GTS NEWSLETTER

TASKI swingo XP

Subassembly: Upper part

Improved tank cover locking mechanism

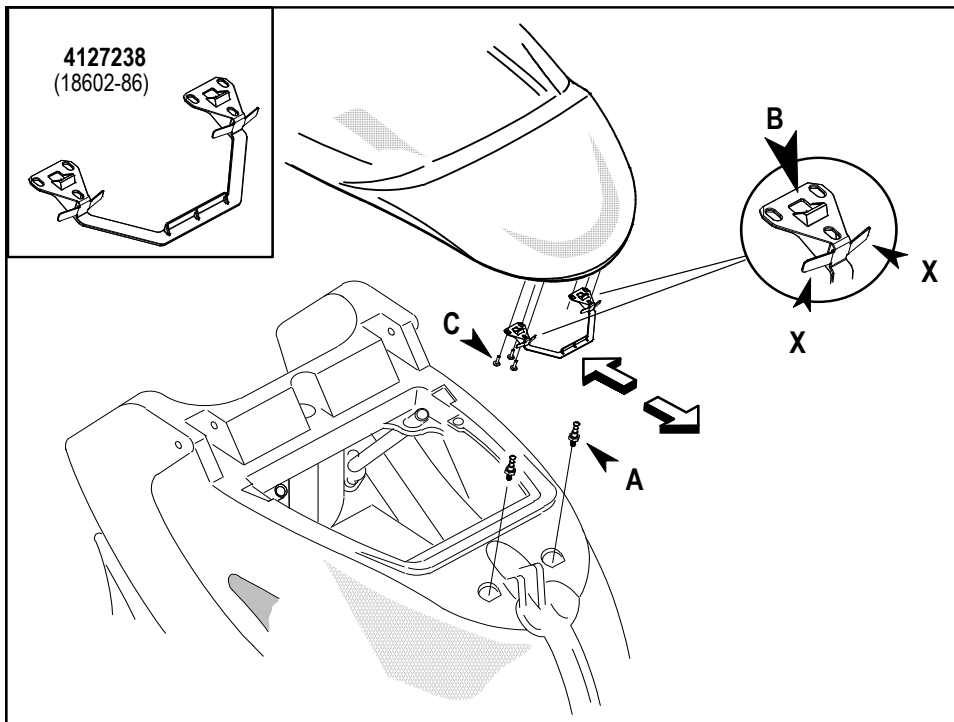
With the new improved locking mechanism for the tank cover, an accidental opening is impeded. To open the cover, the locking bow has to be **PULLED** forward.

The locking bow order-no. 4127238 (18602-86) replaces der rubber locking disc and steel disc. The fixation is done with the same screws.

- All machines can be retrofitted with the new locking mechanism

The screws C should only be tightened as strong that the automatic repositioning of the locking mechanism is ensured.
